OFFICIAL RECALL NOTIFICATION U.S. FEDERAL BOAT SAFETY ACT

## Plug Missing From Turn Key Start Carburetor Retrofit Kits

Flame arrestor decal

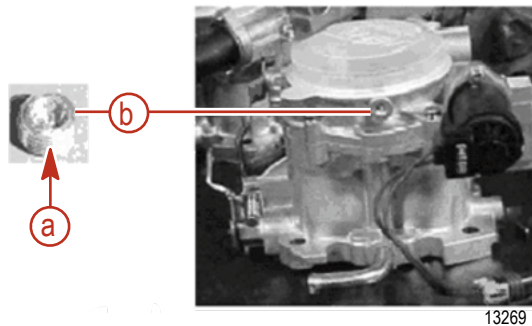
Turn Key Start carburetors can be identified by the words "TURN KEY START" under the displacement designation on the flame arrestor decal and the electrical module mounted on the side of the carburetor.
